MILITARY SPECIFICATION

MODULES, STANDARD ELECTRONIC

MULTIVIBRATOR, MONOSTABLE, DIGITAL, KEY CODE CDE

This amendment forms a part of MIL-M-28787/122B(EC), dated 31 August 1982, and is approved for use within Space and Naval Warfare Systems Command, Department of the Navy, and is available for use by all Departments and Agencies of the Department of Defense.

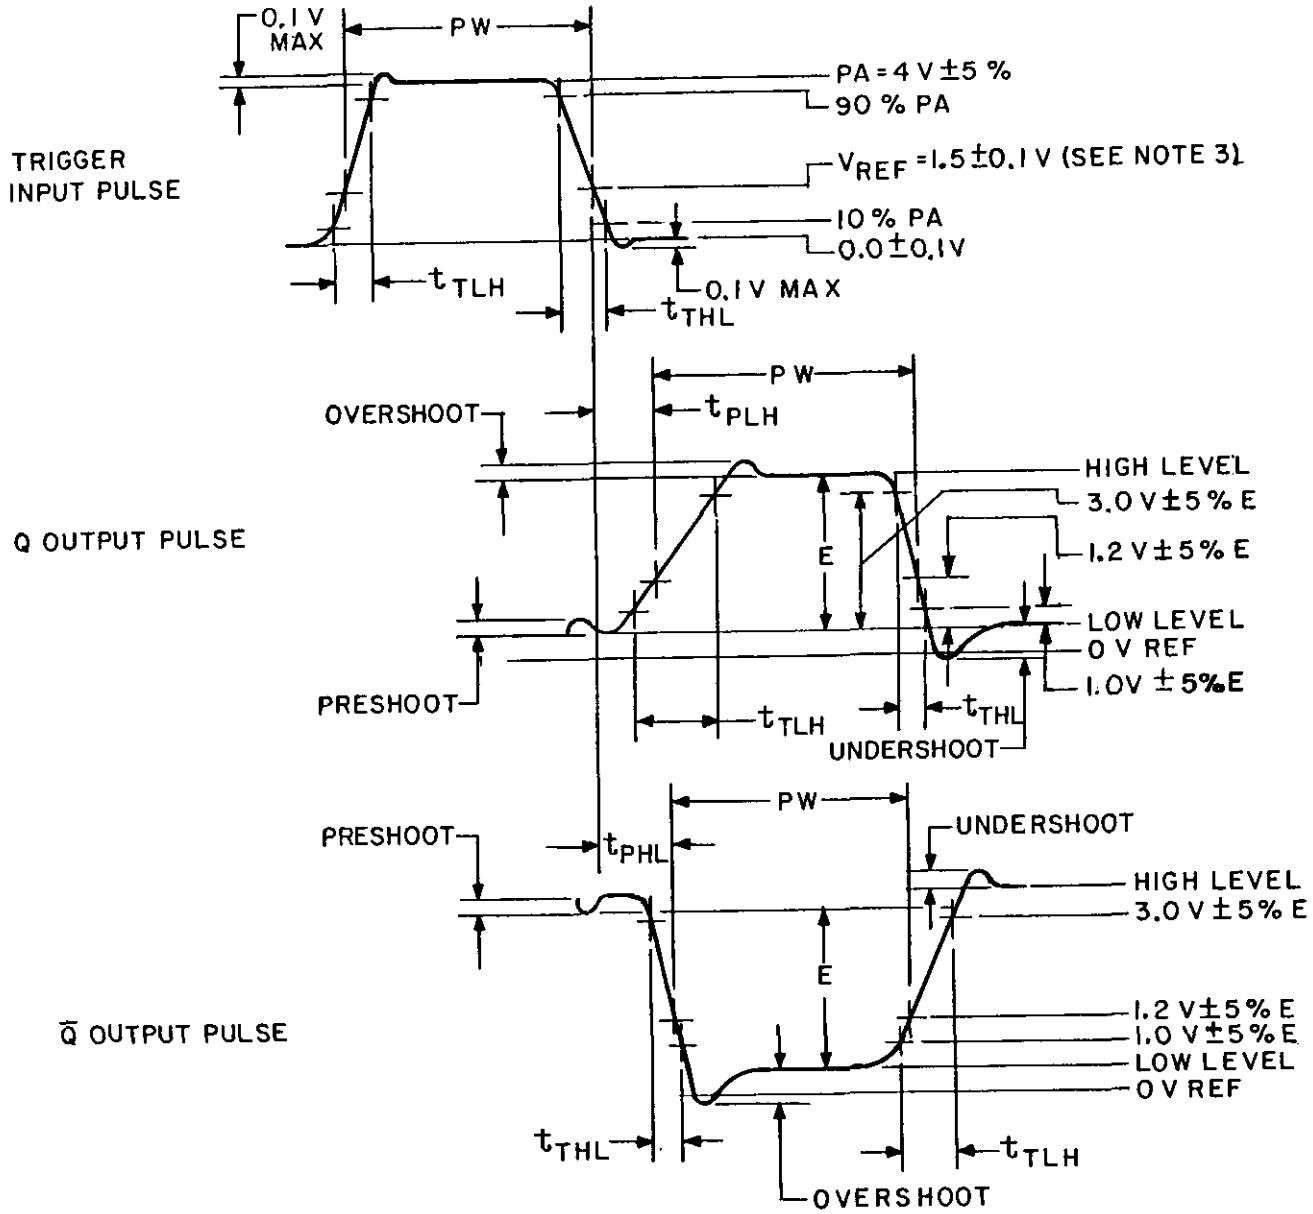
FIGURE 10: Delete and substitute new figure as printed on page 3 of this amendment.
